Re: Peer review - Proposed development at 28-32 Somerset Street, Kingswood (DA22/0326)

EMM has been engaged by Department of Planning and Environment (DPE) to undertake a peer review of the proposed Medi-hotel development located at 28-32 Somerset Street, Kingswood (PPSSWC-244). The subject site comprises three lots known as 28, 30 and 32 Somerset Street which are located at the north-east corner of the intersection of Somerset Street and Hargrave Street. The site frontages are 55.5 m to Somerset Street and 19.8 m to Hargrave Street.

Plate 3.1 Nepean Hospital car parking rates

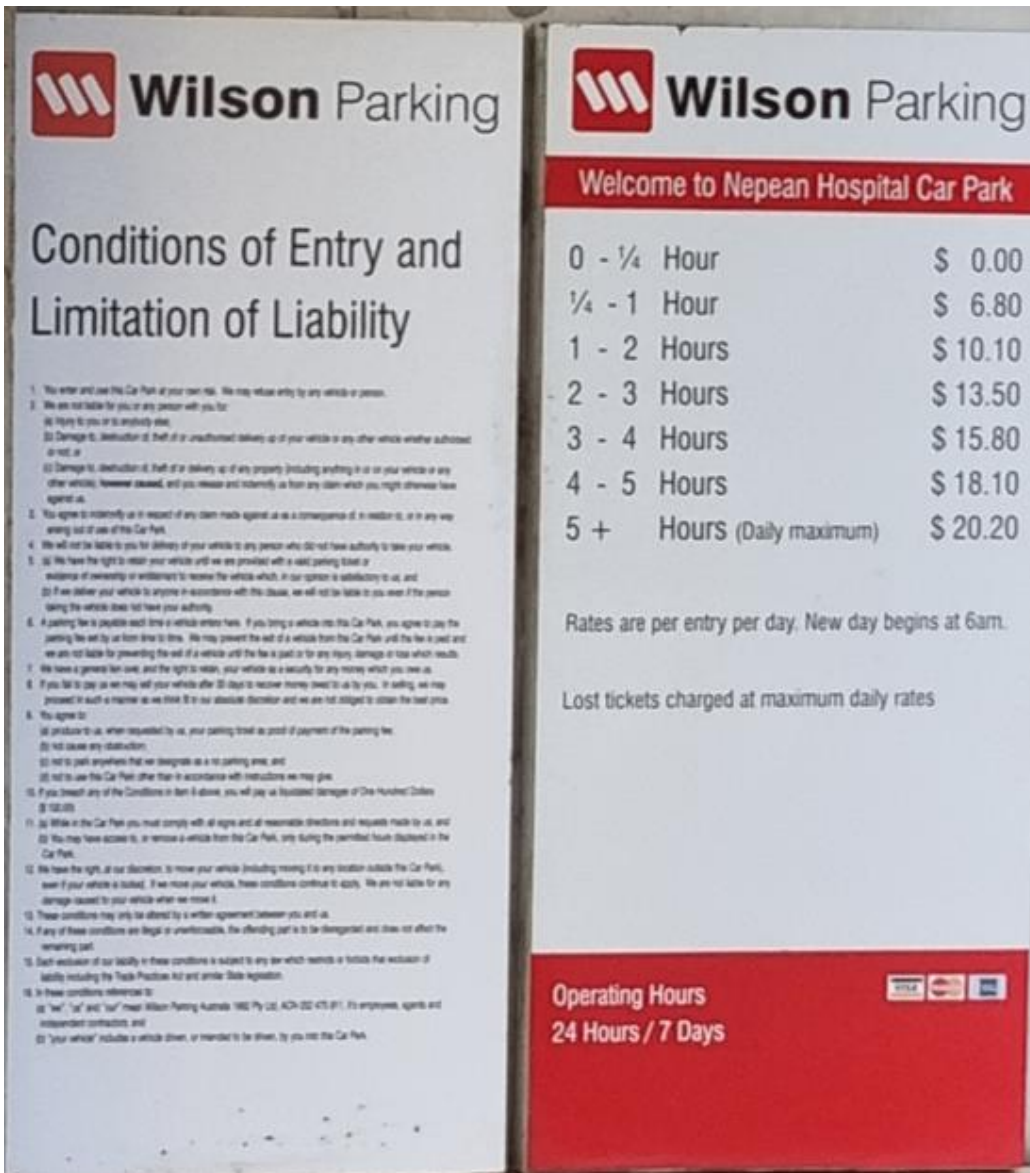
The adjoining street car parking spaces are generally restricted to two to four hours. Should there be any additional car parking demand in exceptional circumstances, there are ample of off-street car parking spaces. For example, the adjoining Nepean Hospital has a [multistorey](#) car park accommodating over 600 spaces which includes 14 spaces for parking with disability. The car park operates 24 hours, 7 days per week with a daily maximum car parking rate is just over \$20 which is considered reasonable (Plate 3.1).

Furthermore, there is another Somerset private and specialist centre [car park](#) has 100 spaces which operates 6 am to 9 pm everyday (Plate 3.2). The maximum car parking rate is \$17 for 15 hours which is considered reasonable. During the site visit on Saturday, 29 April 2023, 88 car parking spaces were notes to be available for this car park.
